Addendum No. 01

Replace Fire Alarm Systems
Mount Vernon Treatment Center
Mount Vernon, MO
Project No: H2312-01

SHEET TITLE:
FIRE PROTECTION
PLAN

FP-1

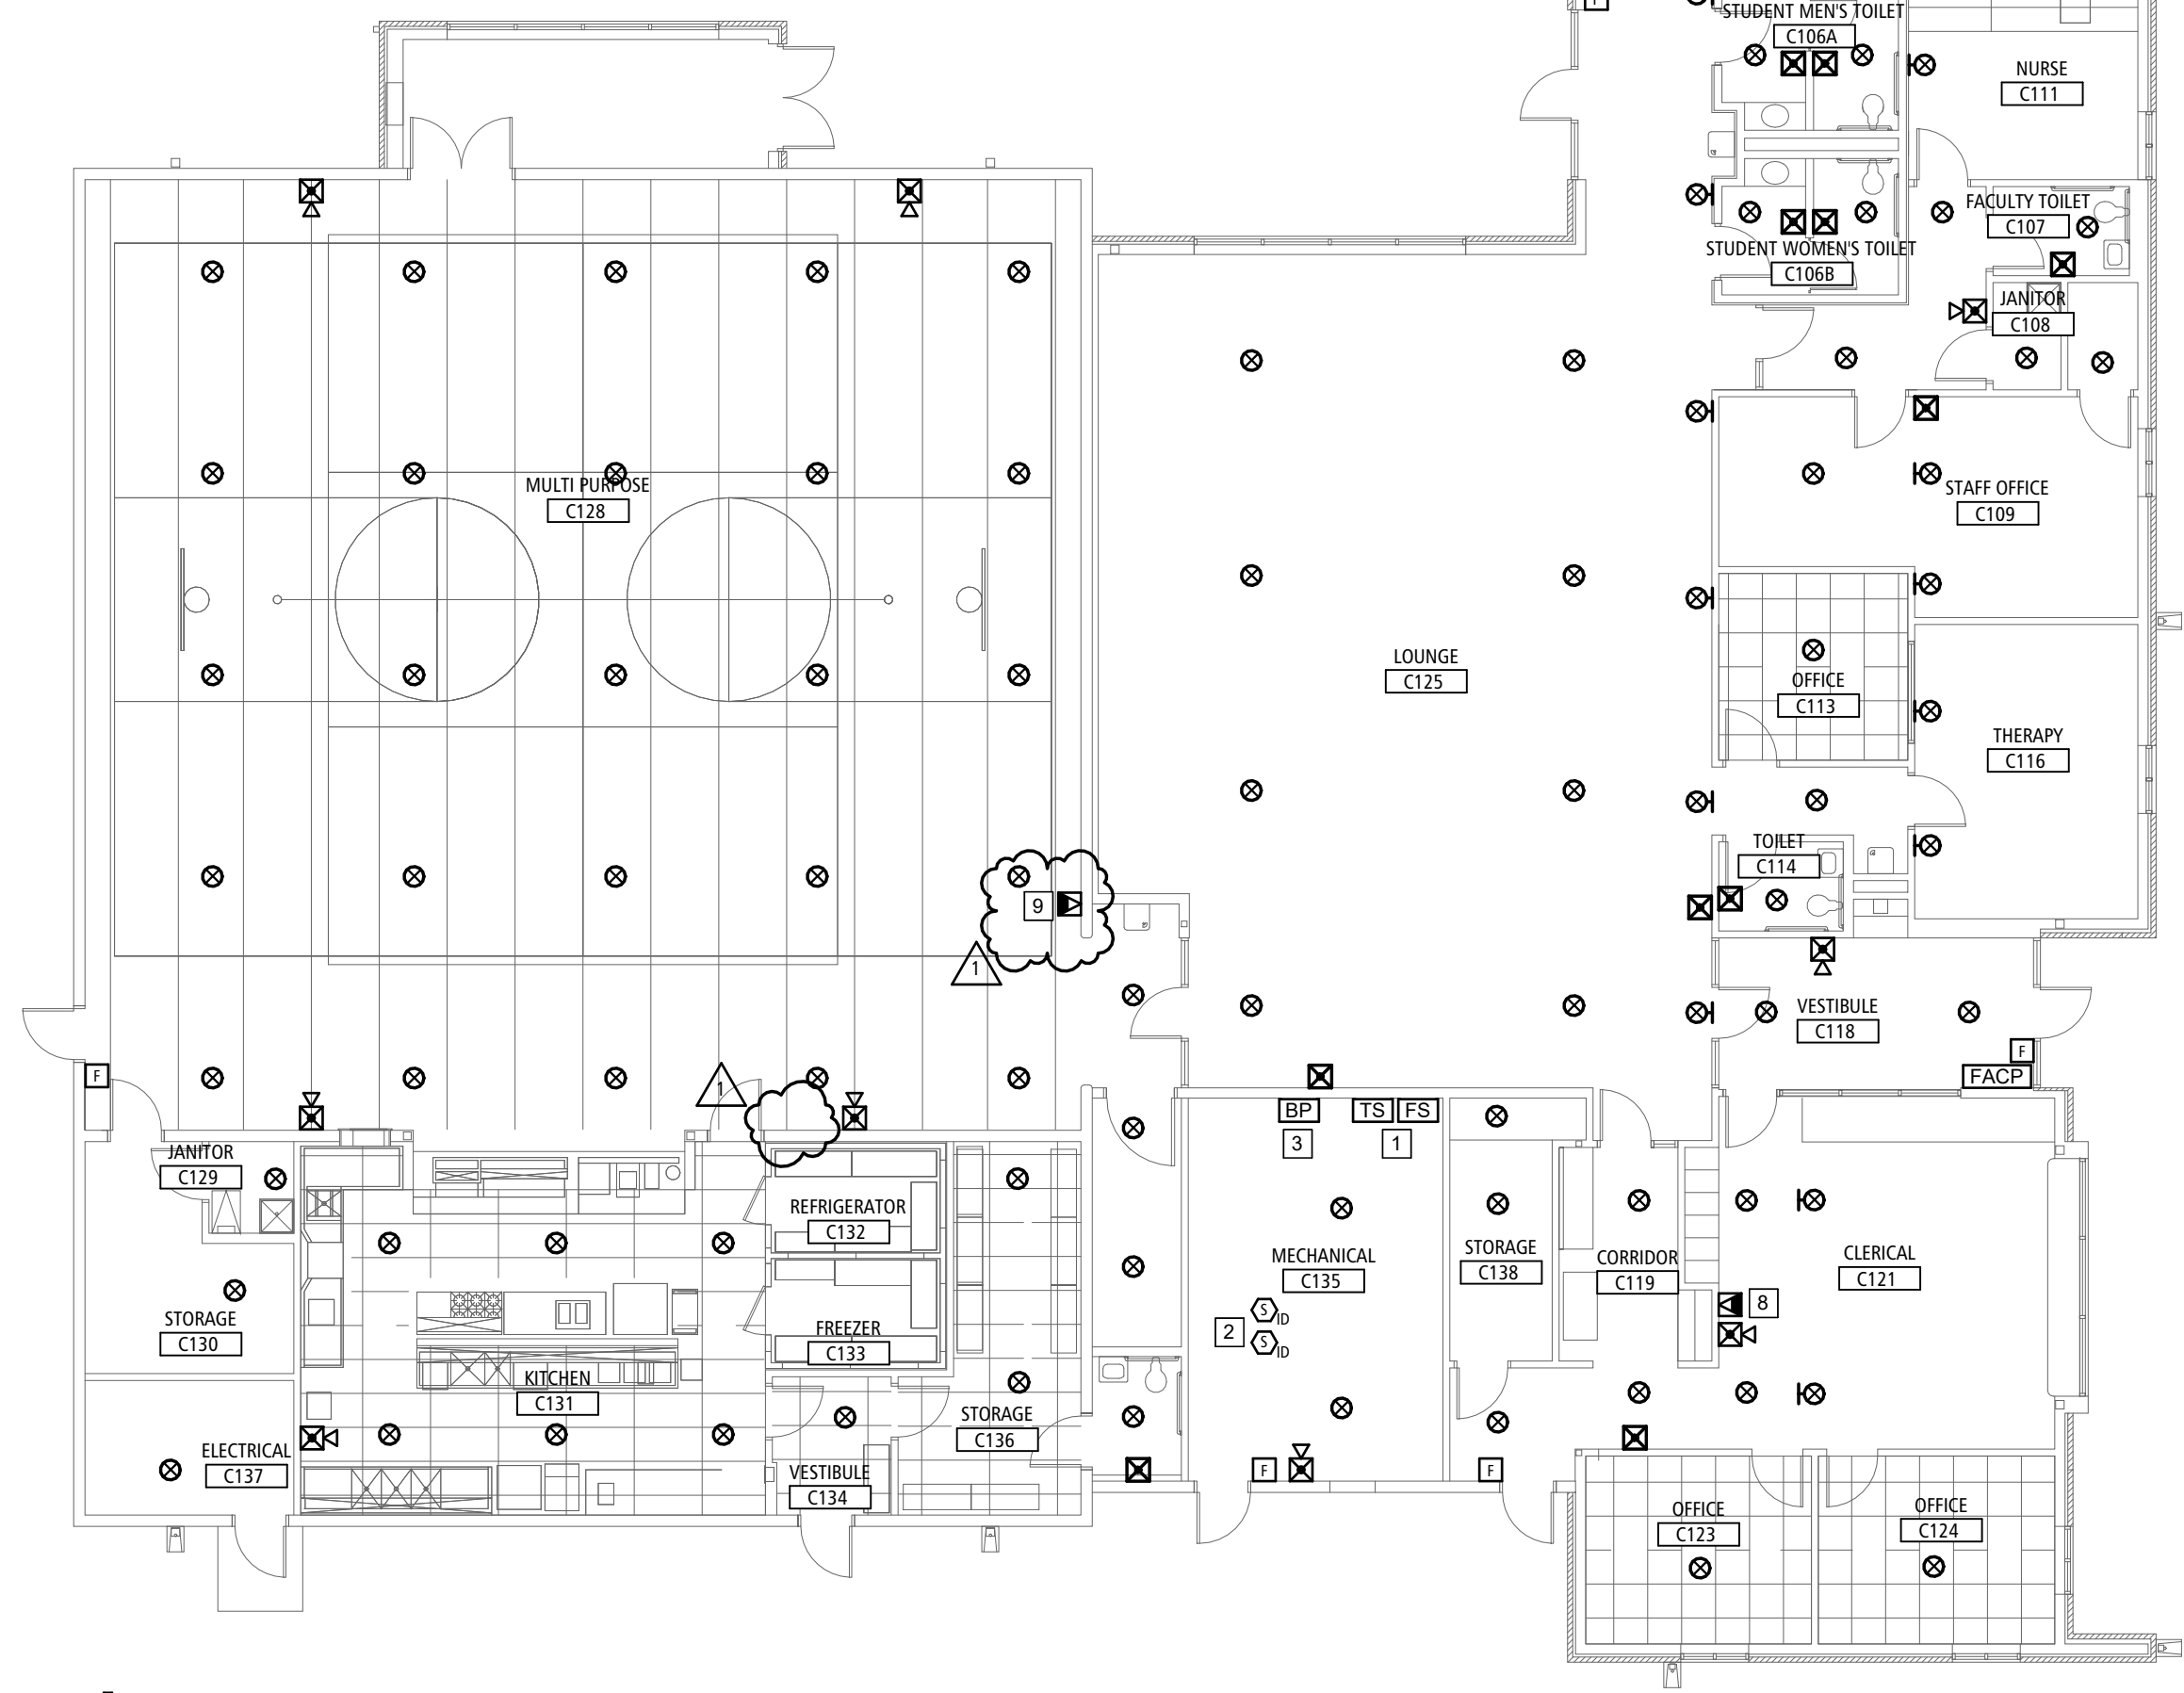
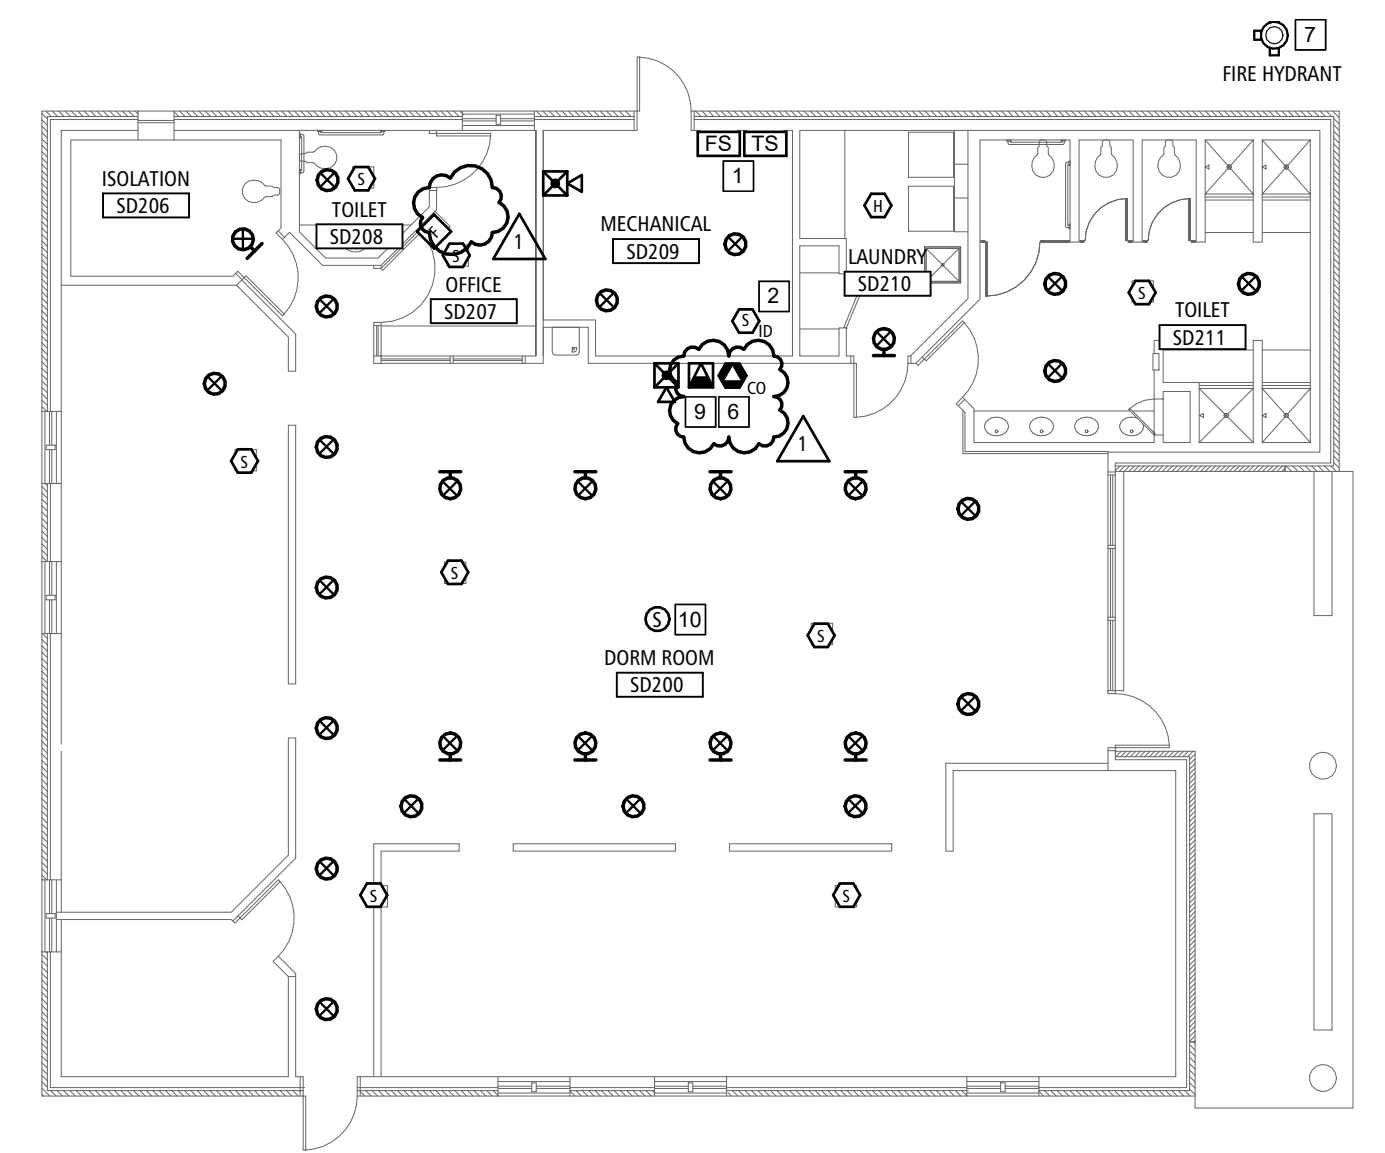
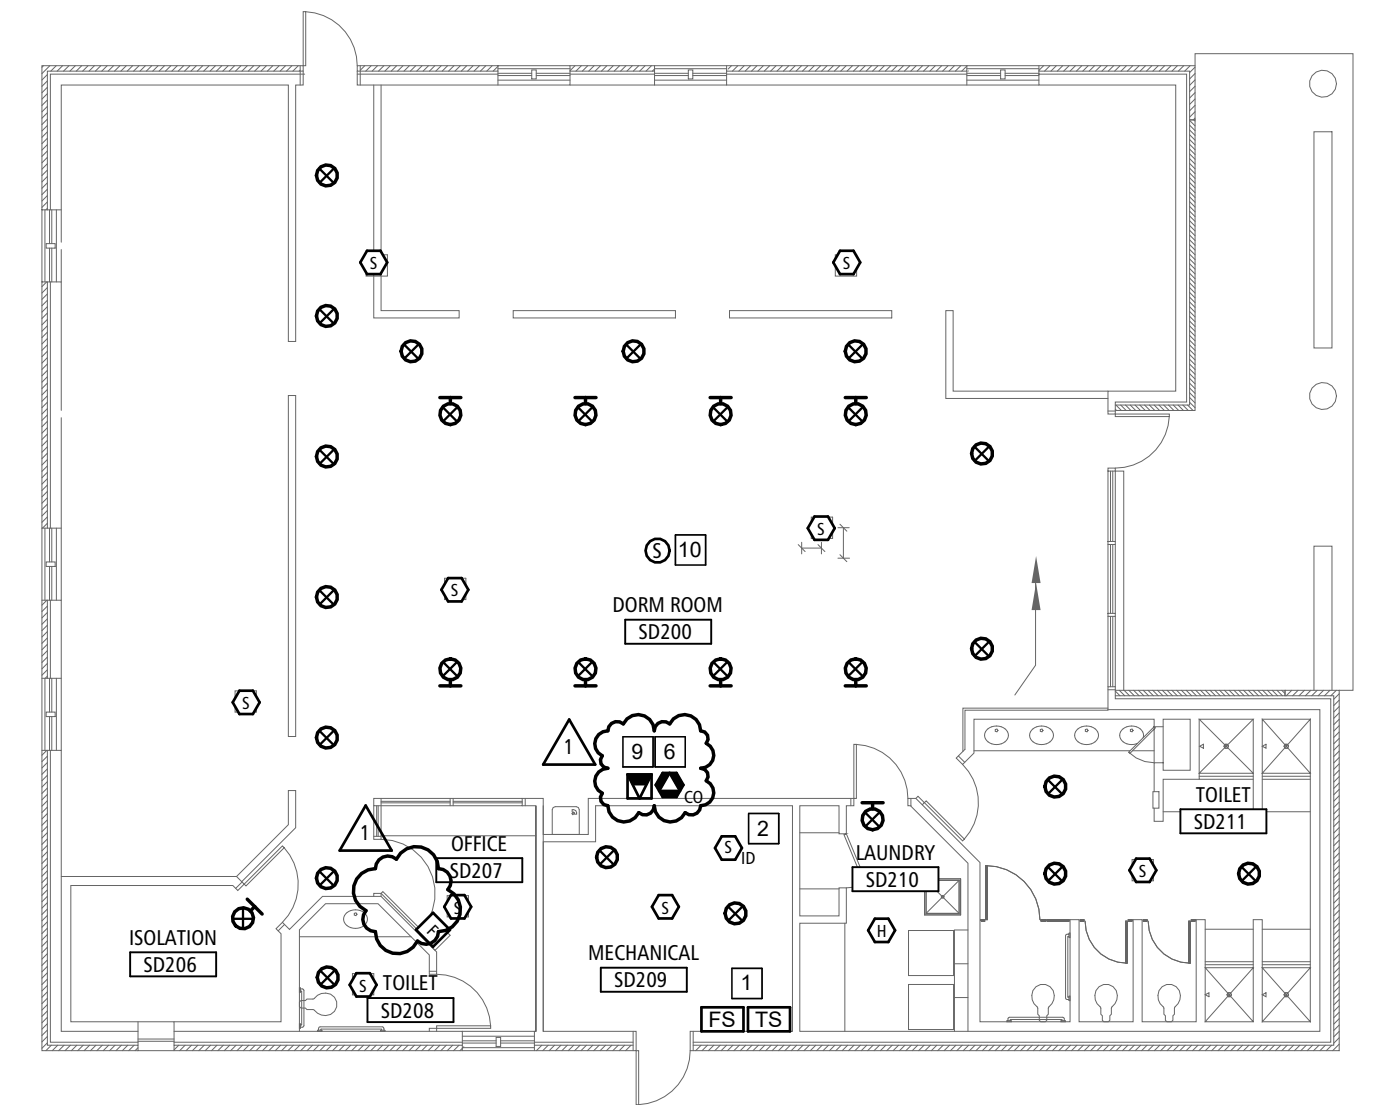
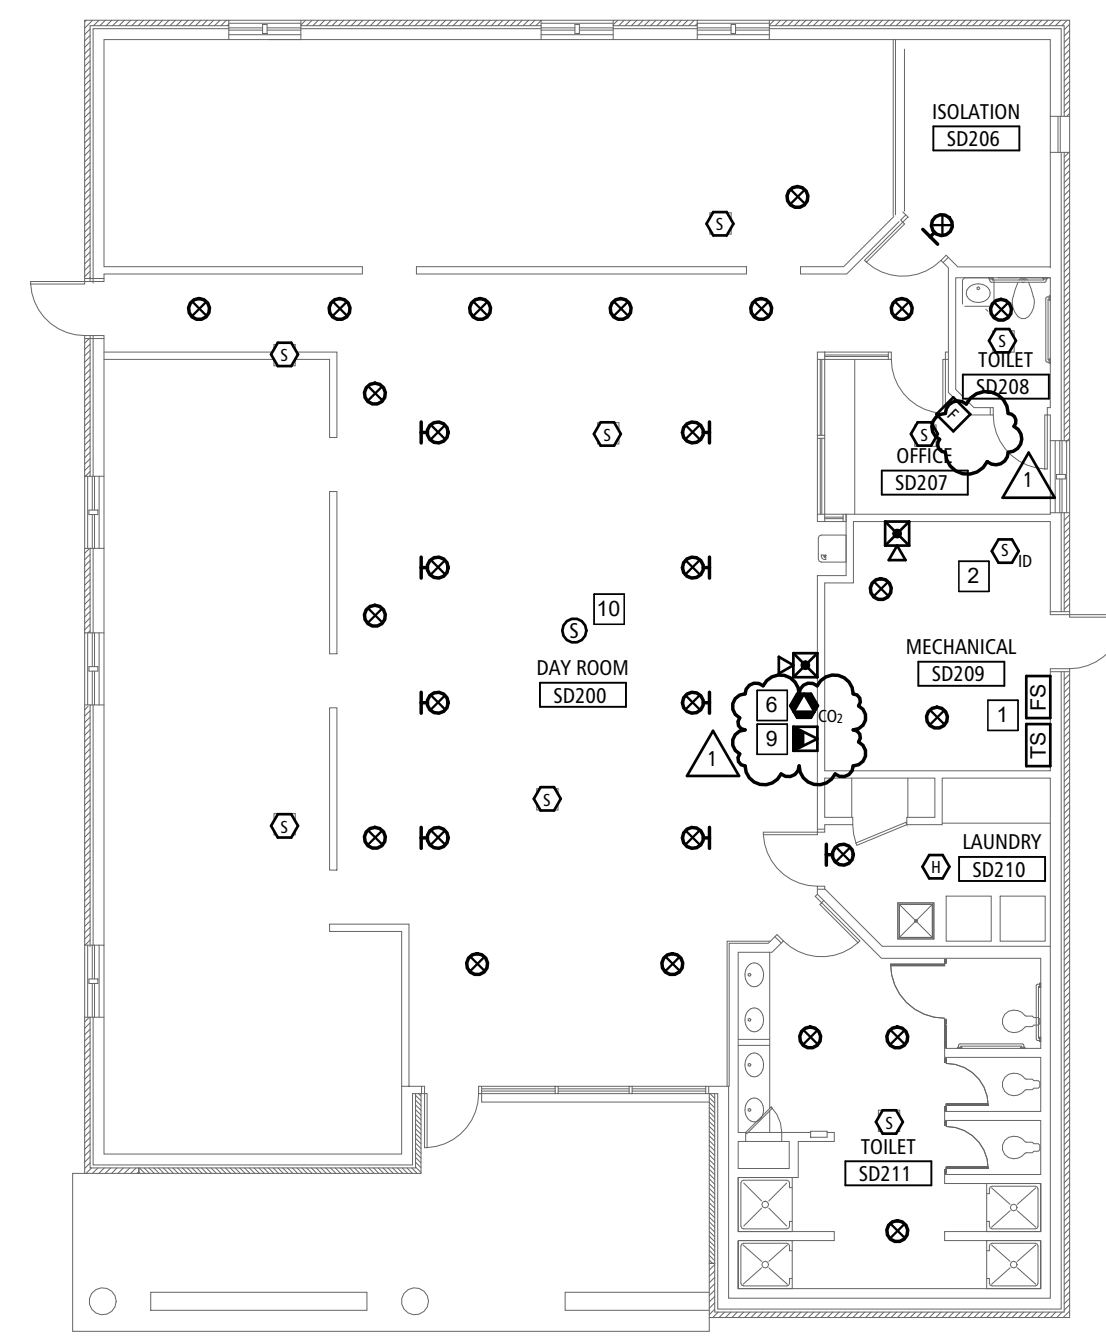
1. Sheet FP-1 – See Attached revised sheet FP-1
 - a. REVISE Keynote 7 as follows:
Replace fire hydrant, including service valve. Field verify connection type and sizing.
 - b. Relocated keynote 9, location on the floor plan to match existing.

- REPLACE FIRE HYDRANT, INCLUDING SERVICE VALVE. FIELD VERIFY CONNECTION TYPE AND SIZING.
- INTERCOM MASTER STATION, EQUAL TO AIPHONE LEF-10C.
- INTERCOM SUB STATION, VANDAL RESISTANT. EQUAL TO AIPHONE LS-NVP/C
